| Project | IEEE 802.16 Broadband Wireless Access Working Group < http://ieee802.org/16 > | |
| Title | Improved CTC Performance | |
| Re: | IEEE P802.16-2004/Cor1-D1 (2005-02-11) | |
| Purpose | To correct CTC channel coding interleaver parameters when supporting H-ARQ. | |

Figure 1. FER performance for currently specified CTC interleavers.

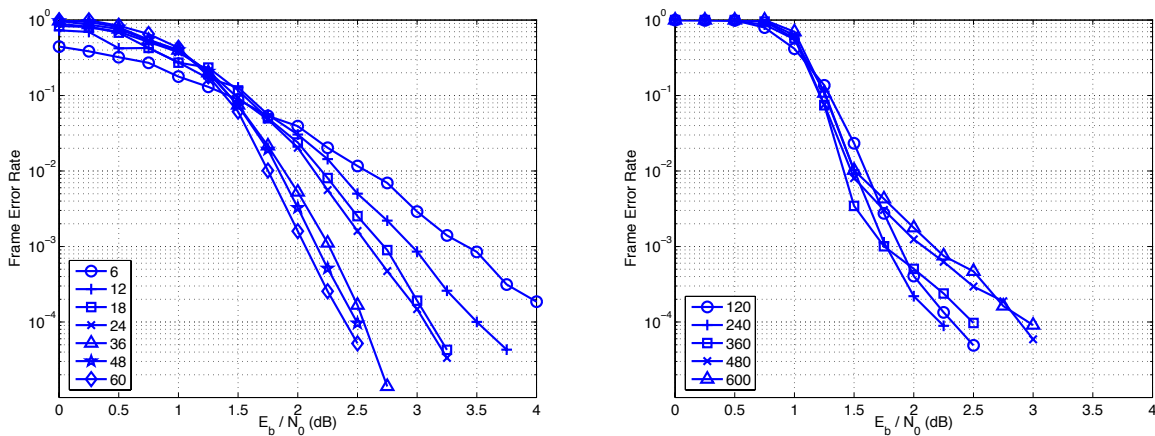
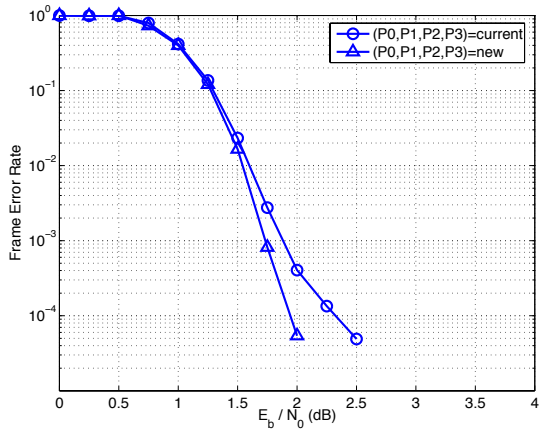
Figure 1 plots the simulated frame error rate (FER) versus E_b/N_0 using the current 802.16 CTC interleaver specification. The results assume a rate-1/2 code, binary modulation over a static additive white Gaussian noise (AWGN) channel, 7.5 decoding iterations, and perfect “genie” knowledge by the decoder of the encoder circulation states. Sub-figure (a) plots results for $6n$ -byte data block sizes ($n = 1, 2, 3, 4, 6, 8, 10$), and sub-figure (b) plots results for the larger $120n$ -byte data block sizes ($n = 1, 2, 3, 4, 5$).

The performance of the $6n$ -byte block sizes displays the expected turbo code behavior of improving performance with increasing block size. Furthermore, no error floor is discernable down to a FER of 10^{-4} . However, the performance of the $120n$ -byte block sizes displays the opposite. Here, the performance degrades with increasing block size (above 240-byte) and a distinct error floor is present.

Figure 2. Performance with new CTC interleaver parameters.

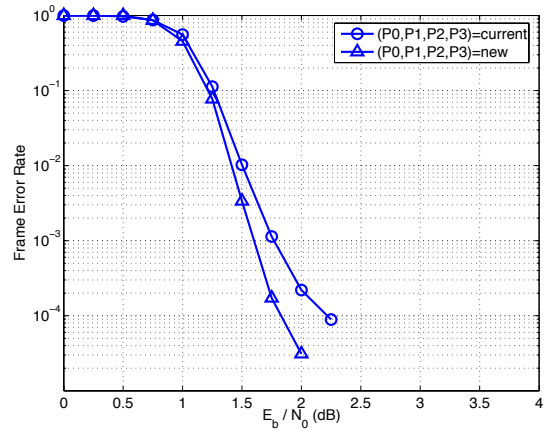
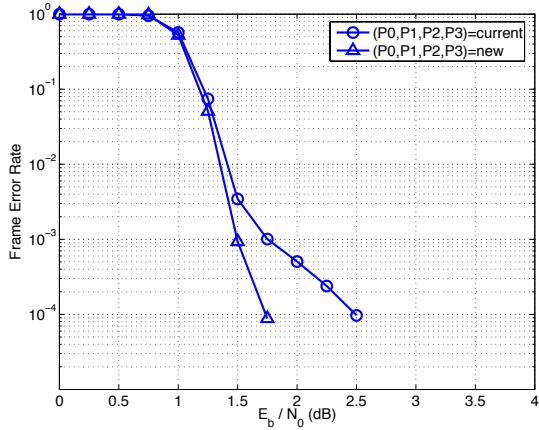
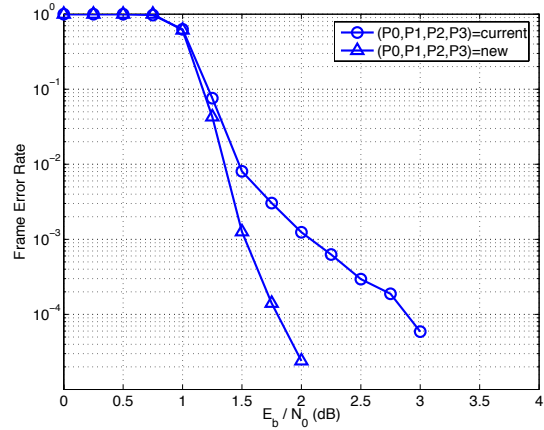
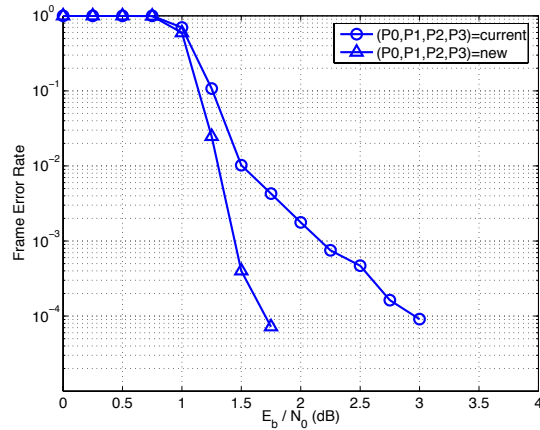
A new set of CTC interleaver parameters was designed to correct the performance deficiencies of the $120n$ -byte block sizes. The new parameters were selected according to guidelines prescribed in [1]. The FER performance (rate-1/2, binary modulation, static AWGN channel, 7.5 decoding iterations, and “genie” circulation state knowledge) with the new parameters is plotted in Figure 2. The figure shows that the new parameters correct the performance deficiencies of the current parameters. At FER = 10^{-4} the performance with the new parameters is at least 0.5 dB and in some cases up to 1.3 dB better than with the current parameters.

<Insert the following to IEEE P802.16-2004/Cor1-D1 (2005-02-11) section 8.4.9.2.3.1 p.110 line 59>
 Change the entries of Table 327 as indicated.

Figure 3. Cross simulation provided by Nortel on the existing and new CTC interleaver parameters.

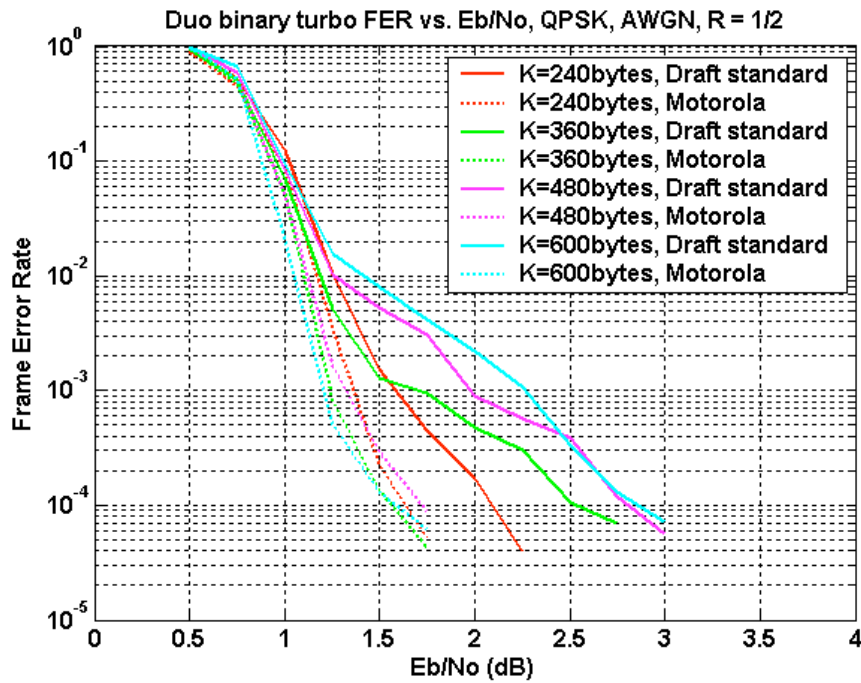
The proposed interleaver parameters have been independently tested by Nortel in comparison to the existing parameters. Their results in Figure 3 further support the significant improvement achieved by the proposed parameters.
